NORTH CENTRAL ELEMENTARY SCHOOL 1

AUSTIN INDEPENDENT SCHOOL DISTRICT
AUSTIN, TEXAS

01 FIRST FLOOR PLAN - AREA 1 - PLUMBING

01 FIRST FLOOR PLAN - AREA 2 - PLUMBING

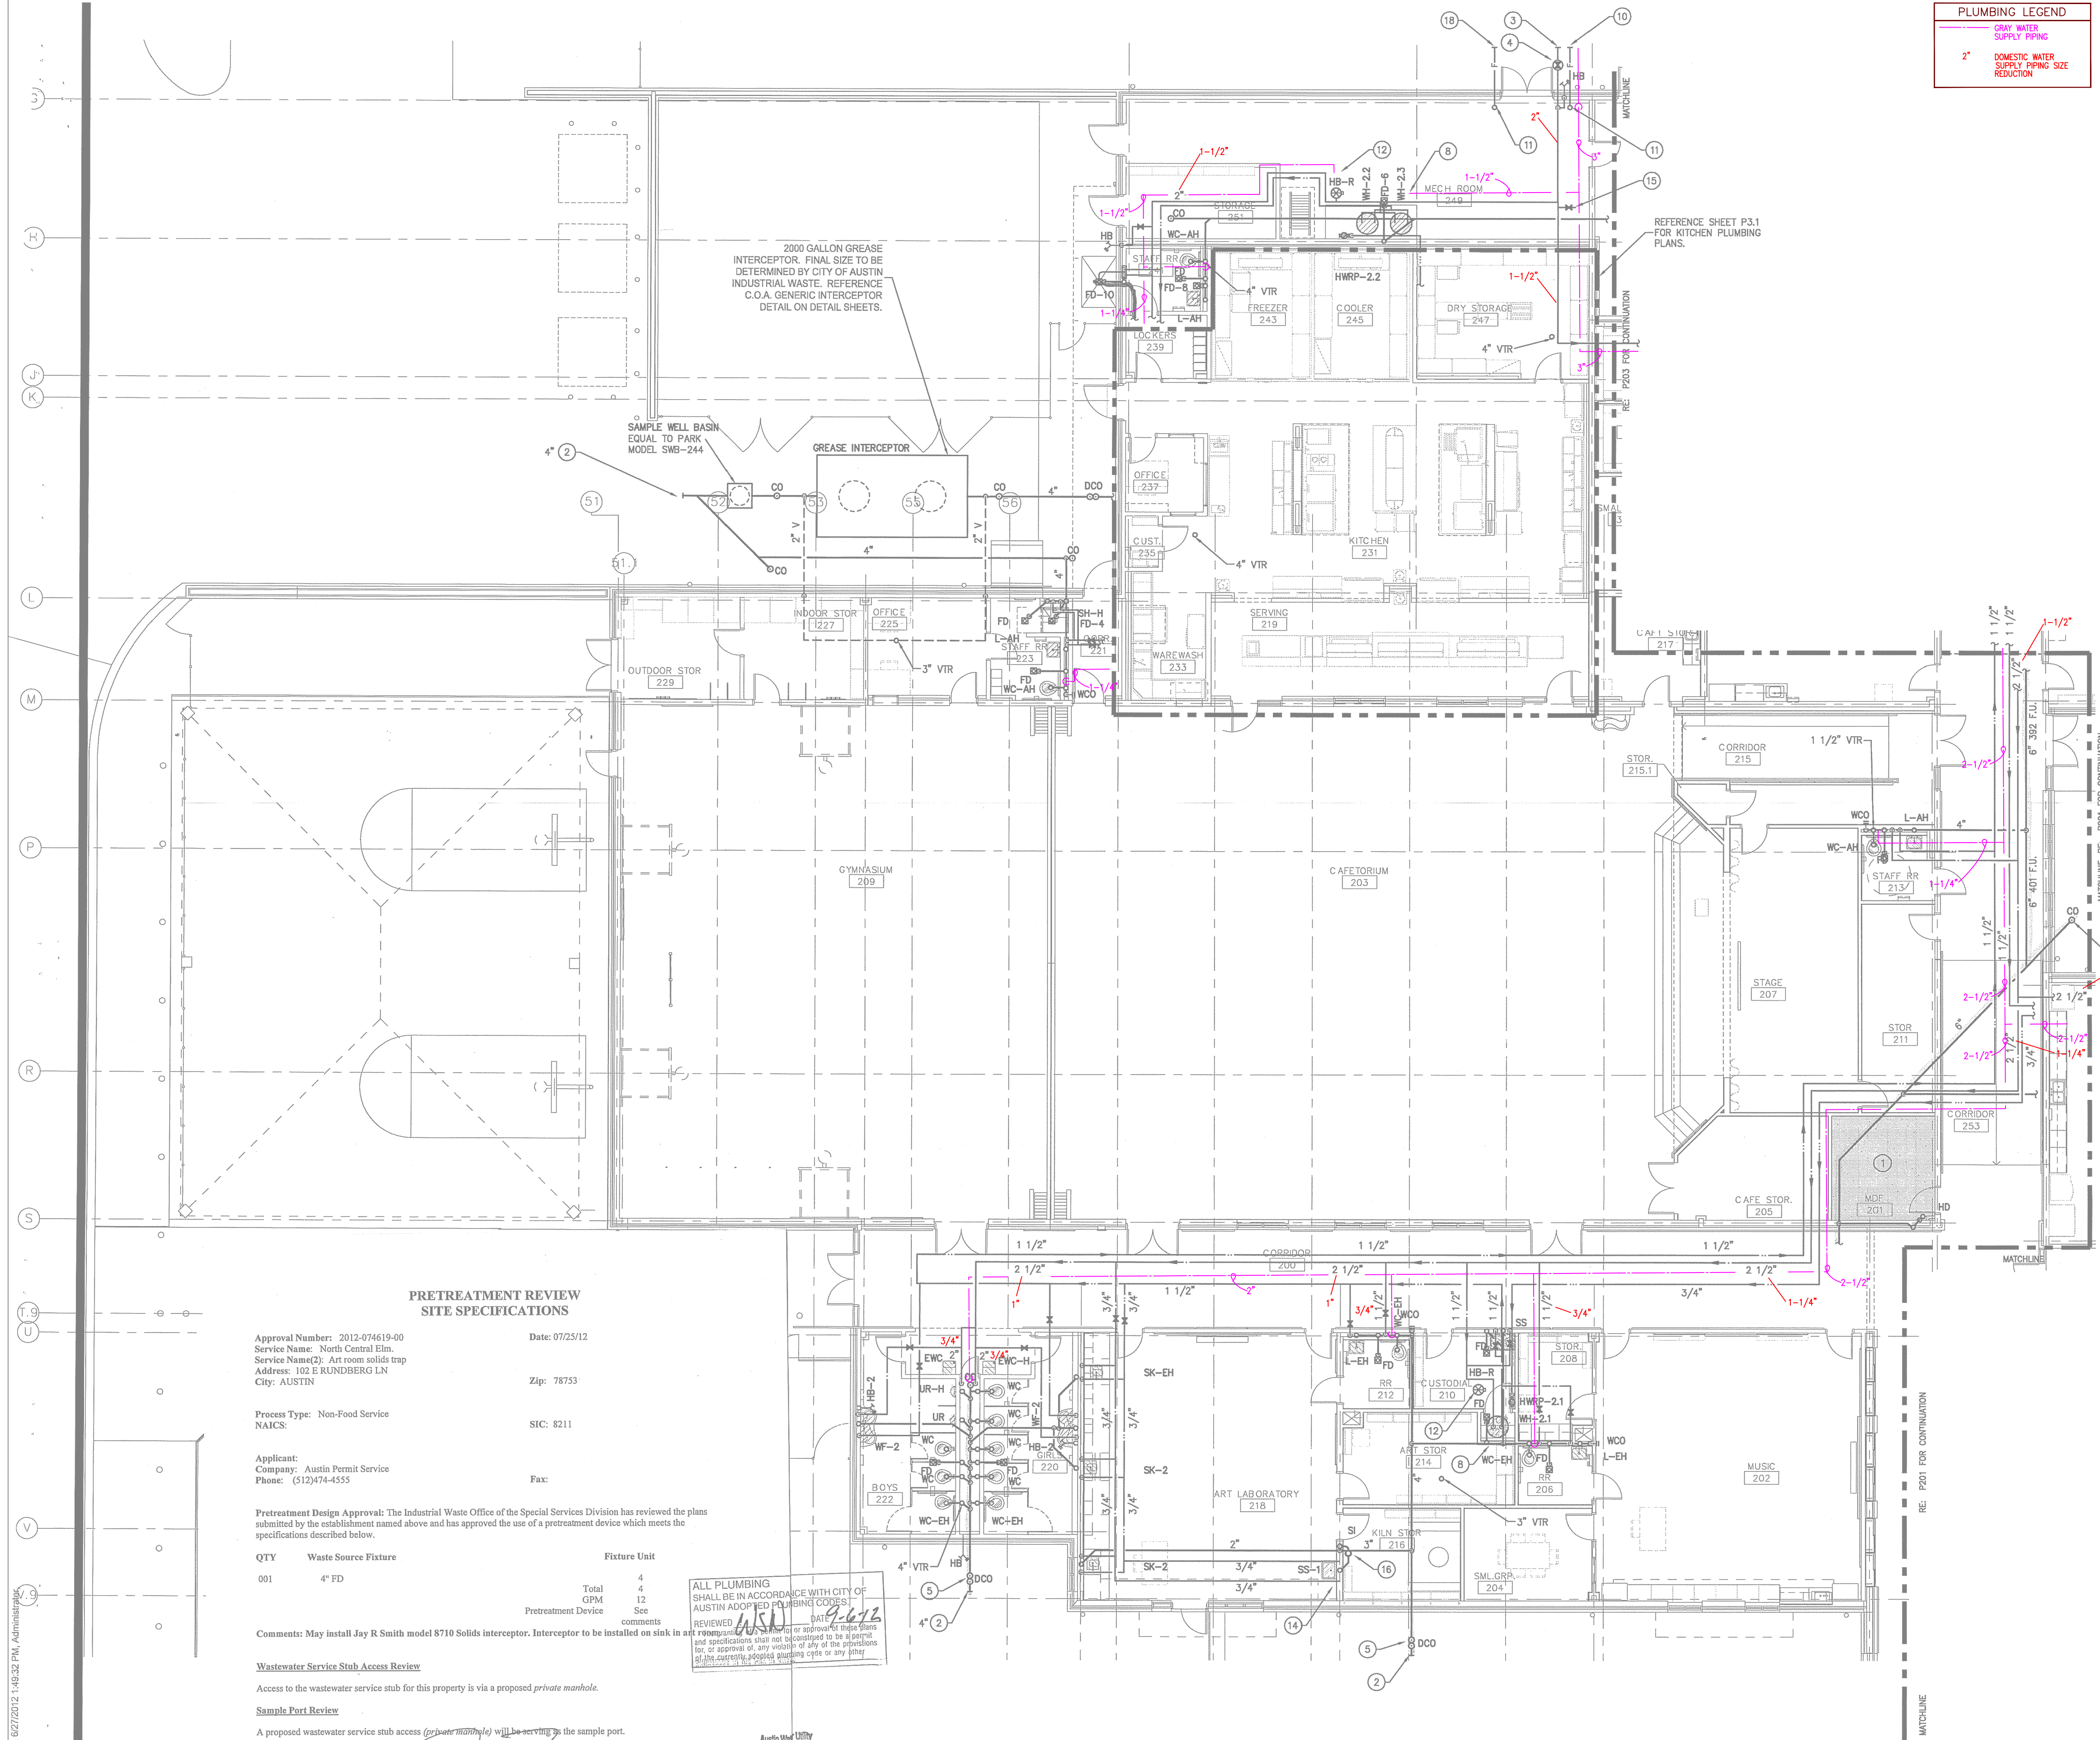
Pretreatment Design Approval: The Industrial Waste Office of the Special Services Division has reviewed the plans submitted by the establishment named above and has approved the use of a pretreatment device which meets the specifications described below.

Comments: May install Jay R Smith model 8710 Solids Interceptor. Interceptor to be installed on sink in art room.

Access to the wastewater service stub for this property is via a proposed private manhole.

A proposed wastewater service stub access (private manhole) will be serving to the sample port.

01 FIRST FLOOR PLAN - AREA 4 - PLUMBING

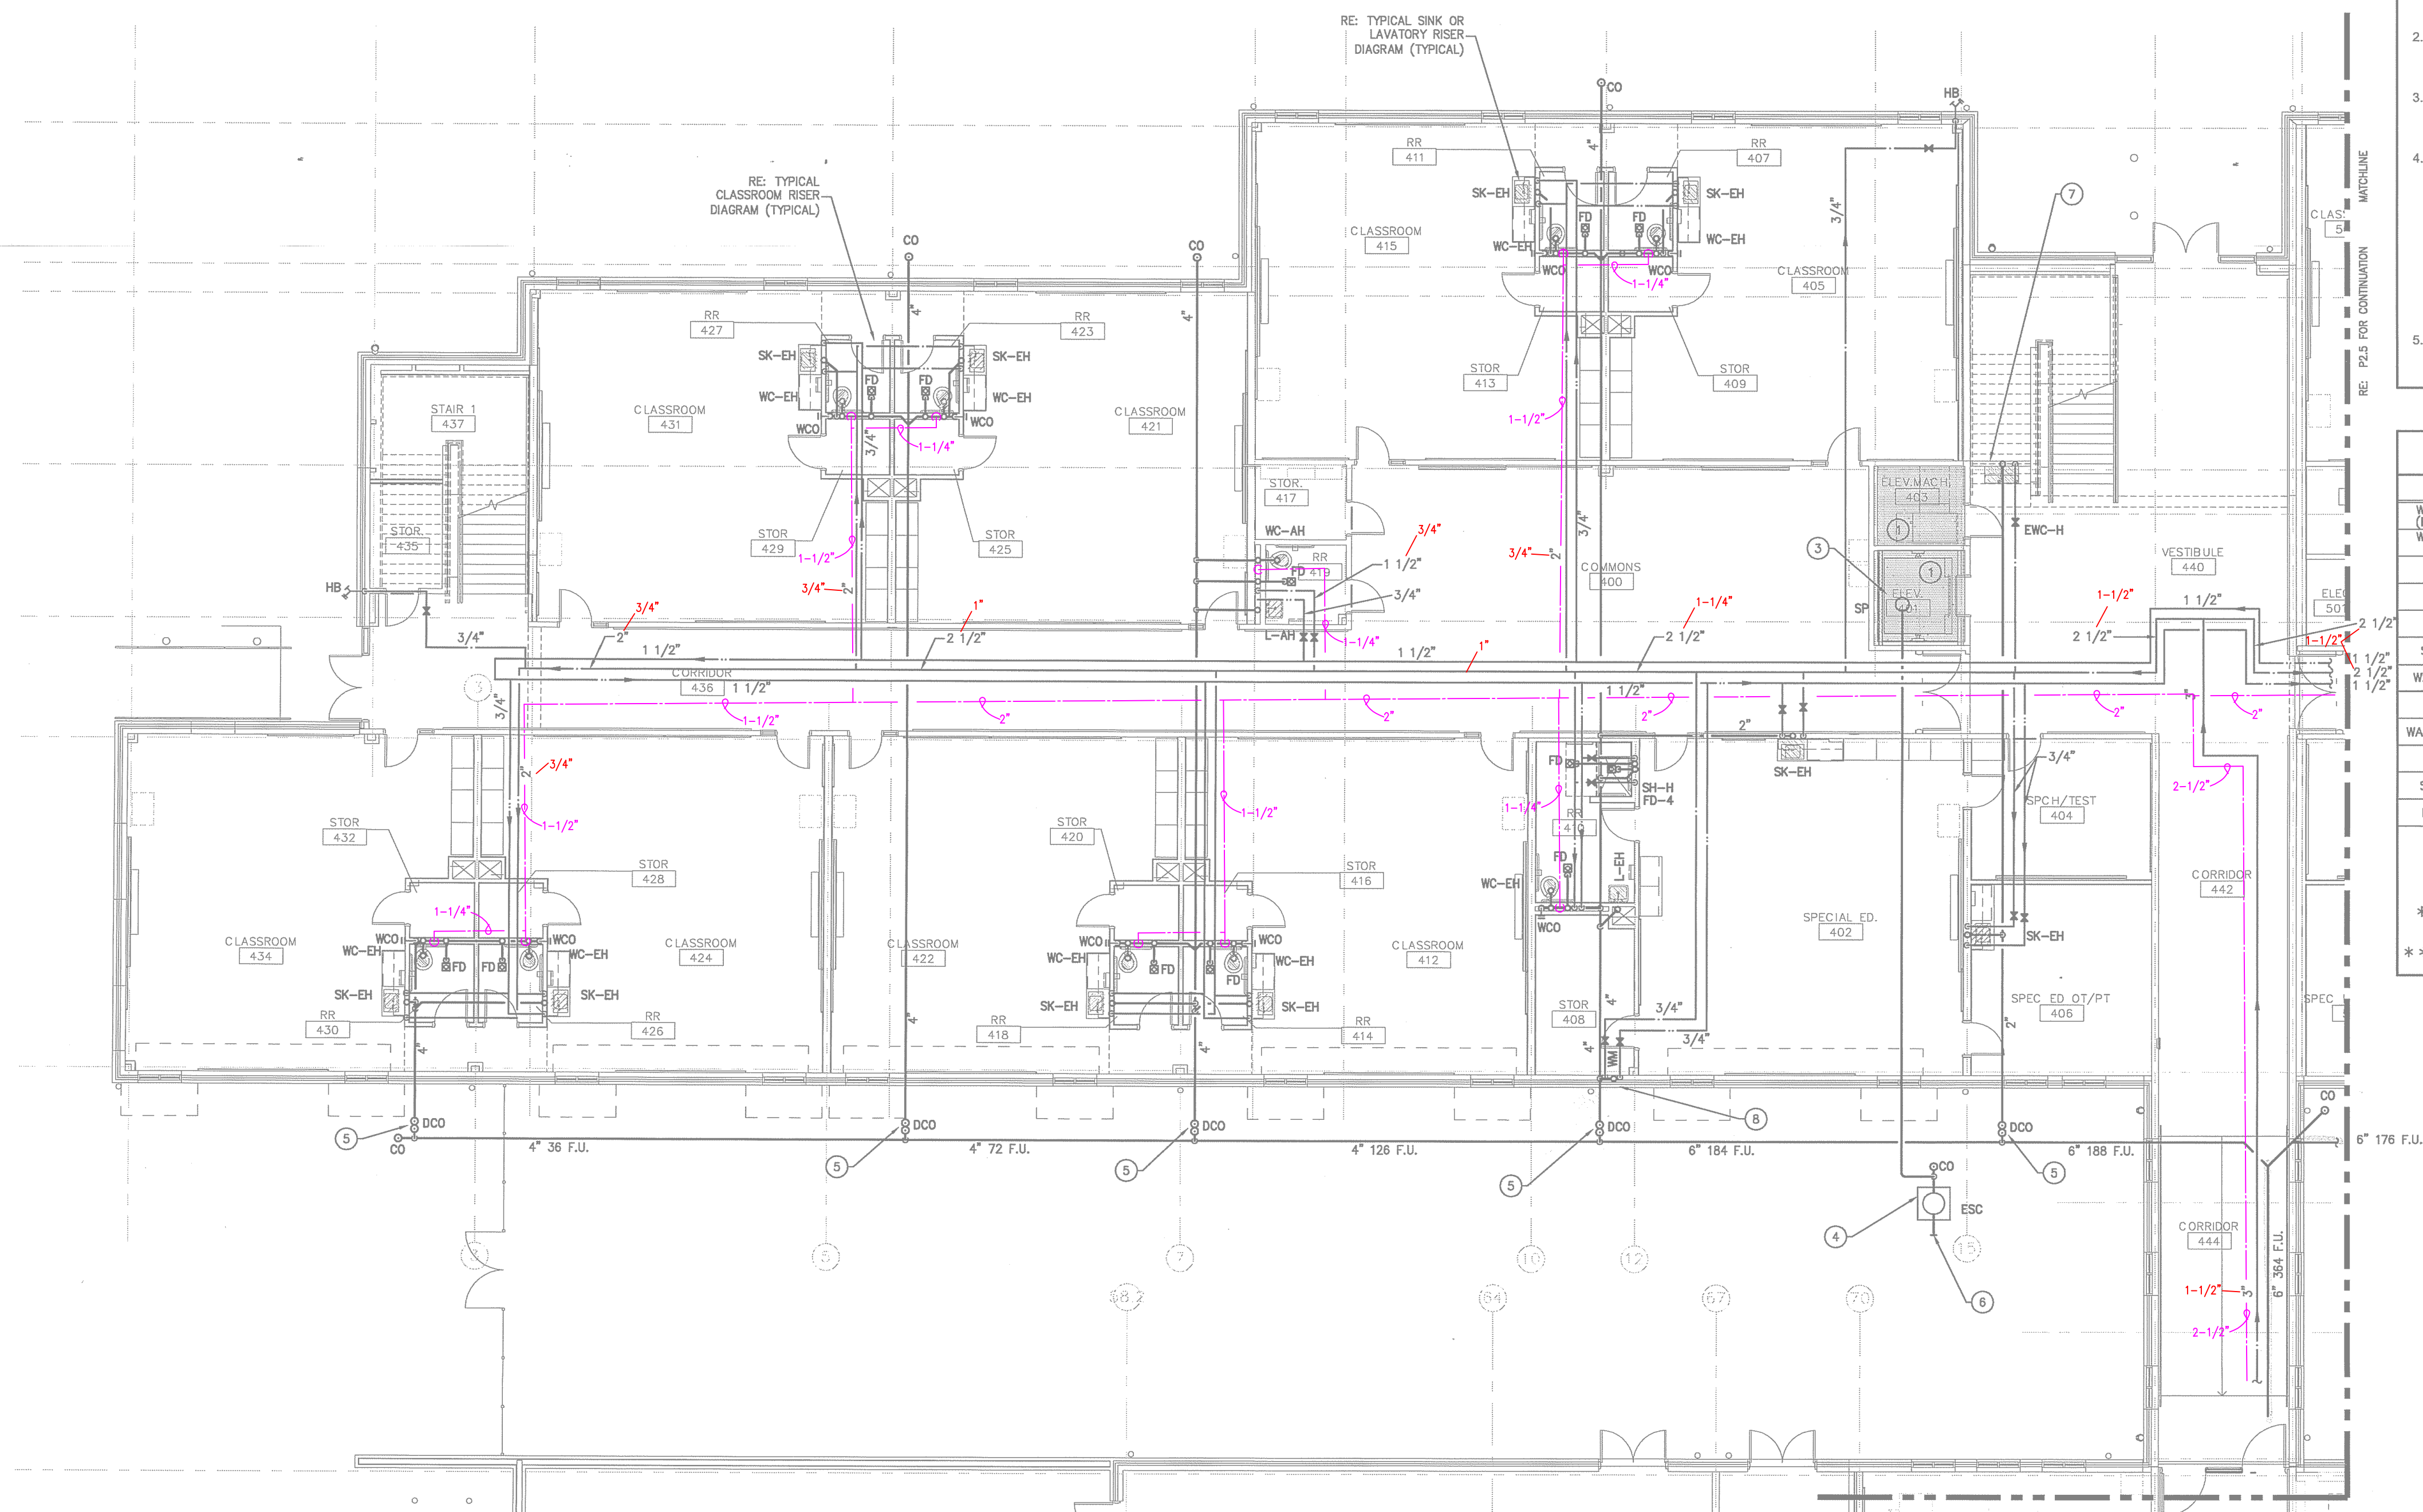
When structurally feasible, traps for floor drains and similar fixtures shall be primed by methods utilizing gravity flow wastewater from acceptable plumbing fixtures. Fixtures used for grease or food particle wasting shall not be used for trap seal priming.

Plumbing fixtures must comply with adopted City of Austin codes and ordinances and State of Texas requirements for plumbing fixture rates:
Water closets- 1.28 gpf
Urinals- 0.5 gpf
Public lavatory- 0.5 gpm
Metered faucets serving the transient public
